Exhibit P5
Special Interest

S11	Comment(s) Audubon Rockies et. al
	<p>Audubon Rockies * Conservation Colorado * Southern Utah Wilderness Alliance The Wilderness Society * Natural Resources Defense Council * Wild Utah Project Western Resource Advocates * National Wildlife Federation * WildEarth Guardians</p> <p>May 22, 2013</p> <p><i>Delivered via electronic mail (GatewaySouth_WYMail@blm.gov) and U.S. mail (with attachments).</i></p> <p>Tamara Gertsch National Project Manager Energy Gateway South Project Bureau of Land Management P.O. Box 21150 Cheyenne, WY 82003</p> <p>Re: Comments on Gateway South Transmission Draft Environmental Impact Statement</p> <p>Dear Ms. Gertsch:</p> <p>These comments on the Draft Environmental Impact Statement (DEIS) for the proposed Gateway South transmission project (GWS) are submitted on behalf of the nine undersigned organizations.</p> <p>Numerous projects across the western states are being pursued to address our nation’s growing energy demands and the need to reduce greenhouse gas emissions from the electricity sector in the face of accelerating climate change. Some of these include large, multi-state transmission lines, such as Gateway South. We r

SI1ci Comment noted.**Figure WY-1:**

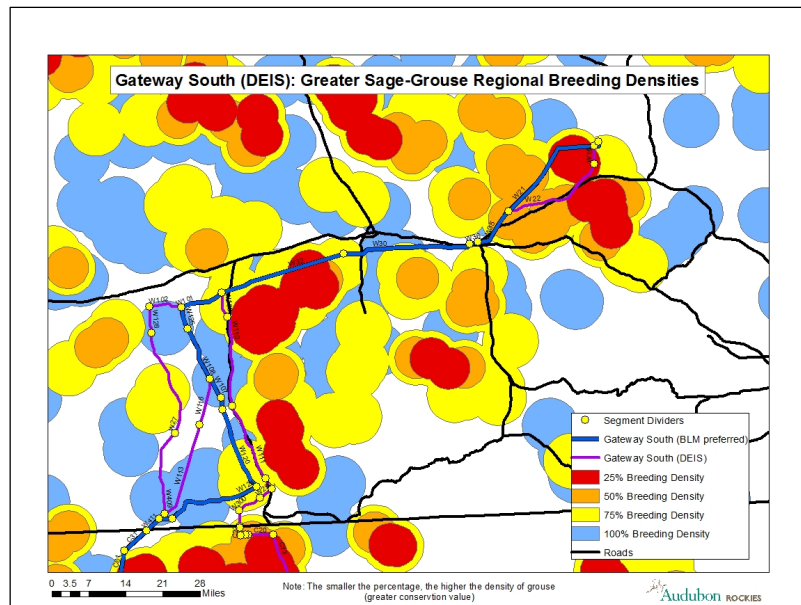
SI1	Audubon Rockies et. al (cont.)	Response(s)
SI1bw	breeding densities. Given Core Areas and documented breeding densities, this segment warrants conservative management going forward to minimize impacts to grouse. [See Figure WY-1 below]	
SI1bx	<ul style="list-style-type: none"> These segments also includes numerous sightings of Ferruginous Hawks (WYNDD), which conservation management going forward to minimize impacts. 	SI1bx
	<p>Segment W36, W30 and W32 (All Alternatives/BLM Preferred)</p> <ul style="list-style-type: none"> <i>Lowest environmental impact</i> Already moderately disturbed and fragmented Intersects Greater South Pass Core Area, but utilizes the Executive Order 2011-05 (Greater Sage-grouse Core Area Protection) designated transmission corridor. South Rawlins Core Area is also just south of the segment. Greater Sage-grouse (GRSG) 25% regional breeding density polygon³ overlaps the segment just east of the designated transmission corridor (indicating the highest density of breeding birds and of the highest conservation priority). Given Core Areas and documented breeding densities, this segment warrants conservative management going forward to minimize impacts to grouse. [See Figure WY-1 below] 	<p>Comment and route preference noted. Potential impacts on raptors under all alternative routes and route variations will be minimized through the application of the design features and selective mitigation measures (refer to Mitigation Planning and Effectiveness in Section 3.2.8.4.3 and Table 3-102).</p>

Figure WY-2:

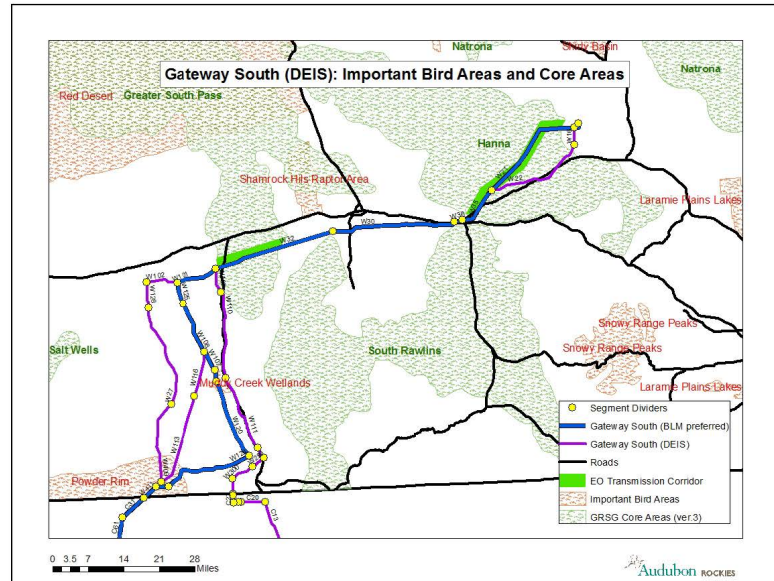
SI1	Audubon Rockies et. al (cont.)
SI1ch	<ul style="list-style-type: none"> GRSG 75% regional breeding density polygon¹ overlaps the eastern half of this segment (indicating high density of leks and breeding birds and of high conservation priority) [See Figure WY-1 below]
SI1ci	<p><u>Segment W302 and W411</u> (BLM Preferred)</p> <ul style="list-style-type: none"> <i>Highest environmental impact</i> – Powder Rim IBA, significant visual impacts, unfragmented habitat Segment entirely encompassed within the Powder Rim IBA (see text above) [See Figure WY-2 below] Virtually no existing disturbance or habitat fragmentation Significant visual impacts in a currently undeveloped landscape

Figure 3: Flowlines, GWS segments, and WVECs scored by risk to flowlines.

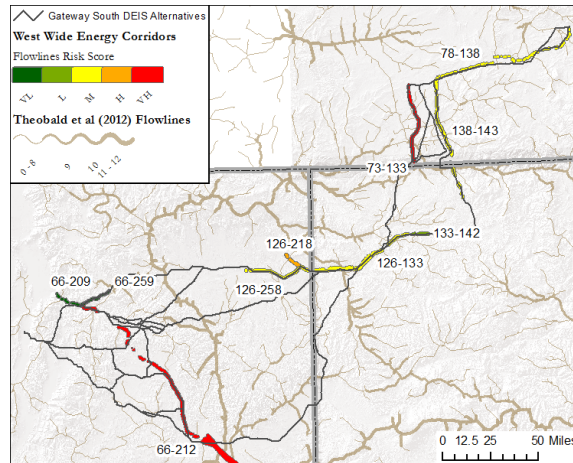
- **WVEC 138-143:** This segment overlaps with long portions of WYCO-D. The WVEC segment scores Very High Risk to CHAT resources, and has a 31% overlap with Greater sage-grouse PACs. If this route is used, we recommend following the National Technical Team's recommendations to exclude new infrastructure ROWs and avoid all new energy infrastructure development within Greater Sage-grouse PACs. Use the full mitigation hierarchy to avoid, minimize, and compensate for impacts within four miles of important sage-grouse breeding areas. Consult closely with state fish & game agencies and WGA to implement the full mitigation hierarchy of avoidance, minimization, and compensation for CHAT resources at "Very High" risk.

Figure 4: Landscape Permeability (Theobald et al 2012), GWS routes, and WVECs scored by risk to permeability.

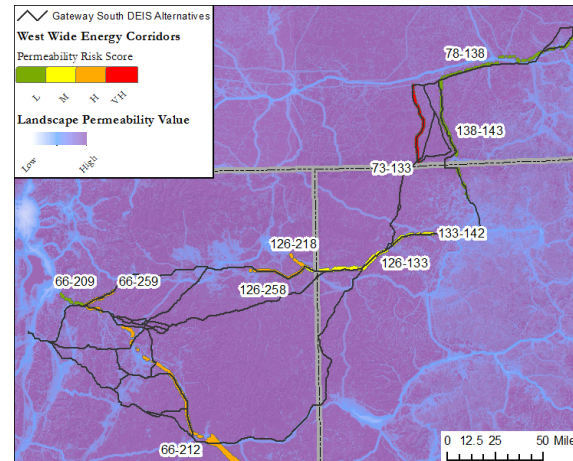
- **WVEC 126-133:** All GWS route alternatives pass through this WVEC segment in northwest Colorado and northeast Utah. The WVEC segment scores Very High Risk to CHAT resources, and has a 33% overlap with Greater sage-grouse PACs. If this route is used, we recommend following the National Technical Team's recommendations to exclude new infrastructure ROWs and avoid all new energy

Figure 1: Figure ES.1 from PacifiCorp 2013 IRP

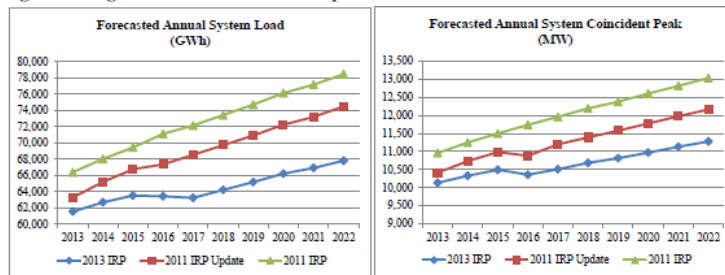
The 2014 DEIS cites important data from PacifiCorp's 2011 Integrated Resource Plan (IRP),² which predates the DEIS by nearly three years even though the DEIS directly referenced PacifiCorp's 2013 IRP.³ The use of old data compromises the DEIS's analysis because the 2013 IRP PacifiCorp lowered many of the growth forecasts cited in the DEIS. The following figures taken from the 2013 PacifiCorp IRP Update, dated April 2013, show how the load forecast from the 2011 IRP (green line with triangles) are much higher than the 2013 IRP (blue line with diamonds).

The difference in Forecasted Annual System Coincident Peak in 2023 is approximately 1,800 MW (13,000 MW - 11,200 MW = 1,800 MW). This is significant because GWS is projected to carry 1,500 MW of capacity, and the difference between the load forecast vintages exceeds the carrying capacity of the proposed line.⁴ PacifiCorp's updated data calls into question the actual need for the proposed project. In order to comply with NEPA, BLM must revise the DEIS to reflect the most recent information on growth forecasts.

Figure 2: PacifiCorp Existing Resources and Future Needs from Figure 4, Appendix A

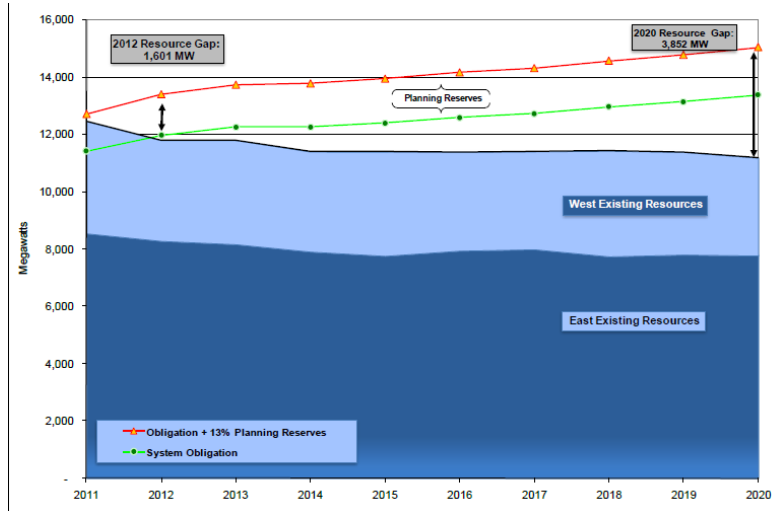
According to the DEIS, PacifiCorp currently has 12,500 MW of existing resources and projects that it will need 15,000 MW of resources (including a 13 percent reserve margin) by 2023.⁹ The DEIS summarized this information as a graphic in Figure 4 of Appendix A, which is shown below.¹⁰

Figure 4 is taken from Figure ES.2 System Capacity Resource Gap from the PacifiCorp 2011 IRP.¹¹ The figure projects that PacifiCorp will have a resource gap of 3,852 MW by 2020.¹² Inconsistent with NEPA, the DEIS relied upon dated forecasts and did not reflect current forecasts made by PacifiCorp.

Figure 3: PacifiCorp 2013 IRP Update, System Capacity Position Trend

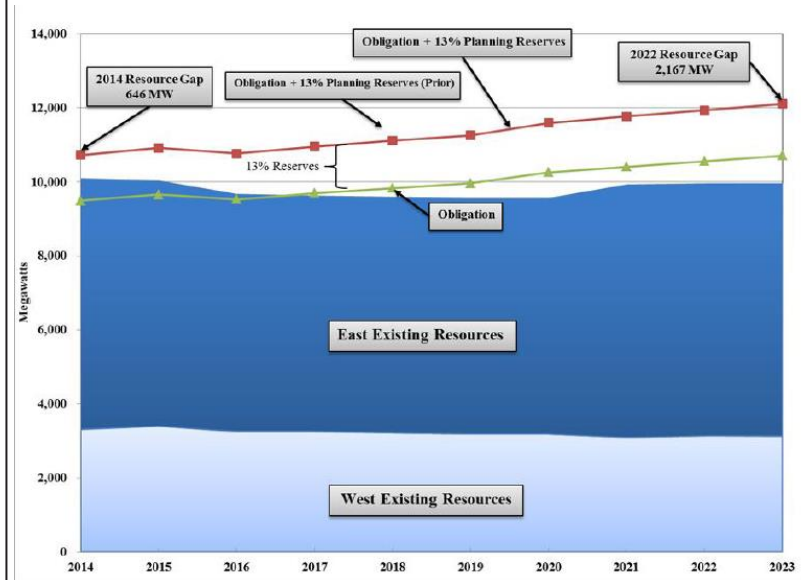
In March 2014, PacifiCorp released its 2013 IRP Update, which modifies the resource forecast.¹⁶ The 2013 IRP Update adjusts the 2014 Existing Resource to 10,085 MW in 2014 and forecasts a resource need (including reserves) of 11,596 MW in 2020.¹⁷ The 2013 IRP Update resource need is 166 MW lower than the 2013 IRP. The resource gap in 2020 in the 2013 IRP Update is 2,042 MW, or 1,810 MW lower than the gap cited in the DEIS. This is a considerable adjustment and is reflected in the following graph of the 2013 IRP System Capacity Position Trend.¹⁸

Figure 1: Figure ES.1 from PacifiCorp 2013 IRP

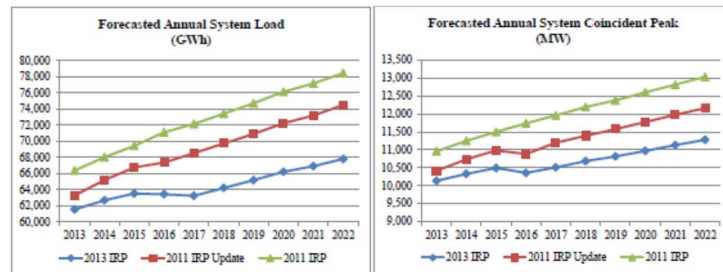
The 2014 DEIS cites important data from PacifiCorp’s 2011 Integrated Resource Plan (IRP),² even though the DEIS directly referenced PacifiCorp’s 2013 IRP.³ The 2011 IRP is nearly three years older than the draft DEIS. The use of old data compromises the DEIS’s analysis because the 2013 IRP PacifiCorp lowered many of the growth forecasts cited in the DEIS. The following figures taken from the 2013 PacifiCorp IRP Update, dated April 2013, show how the load forecast from the 2011 IRP (green line with triangles) are much higher than the 2013 IRP (blue line with diamonds).

The difference in Forecasted Annual System Coincident Peak in 2023 is approximately 1,800 MW (13,000 MW - 11,200 MW = 1,800 MW). This is significant because the Gateway South Project is projected to

Figure 2: PacifiCorp Existing Resources and Future Needs from Figure 4, Appendix A

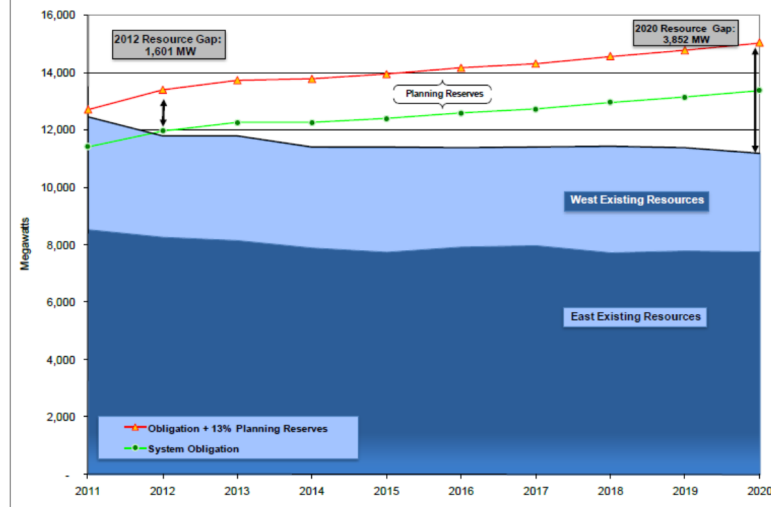
According to the DEIS, PacifiCorp currently has 12,500 MW of existing resources and projects that it will need 15,000 MW of resources (including a 13 percent reserve margin) by 2023.⁹ The DEIS summarized this information as a graphic in Figure 4 of Appendix A, which is shown below.¹⁰

Figure 4 is taken from Figure ES.2 System Capacity Resource Gap from the PacifiCorp 2011 IRP.¹¹ The figure projects that PacifiCorp will have a resource gap of 3,852 MW by 2020.¹² Inconsistent with NEPA, the DEIS relied upon dated forecasts and did not reflect current forecasts made by PacifiCorp.

Figure 3: PacifiCorp 2013 IRP Update, System Capacity Position Trend

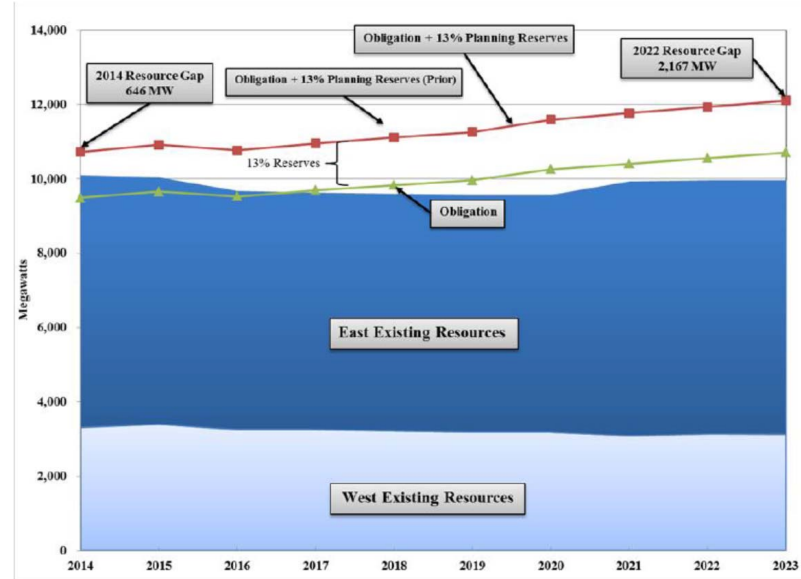
In March 2014, PacifiCorp released its 2013 Integrated Resource Plan Update, which modifies the resource forecast.¹⁶ The 2013 IRP Update adjusts the 2014 Existing Resource to 10,085 MW in 2014 and forecasts a resource need (including reserves) of 11,596 MW in 2020.¹⁷ The 2013 IRP Update resource need is 166 MW lower than the 2013 IRP. The resource gap in 2020 in the 2013 IRP Update is 2,042 MW, or 1,810 MW lower than the gap cited in the DEIS. This is a considerable adjustment and is reflected in the following graph of the 2013 IRP System Capacity Position Trend.¹⁸

For accuracy, the updates in the PacifiCorp load forecasts and resource needs must be factored into the DEIS. These updated values show that by relying on stale data the DEIS overstates the capacity gap,
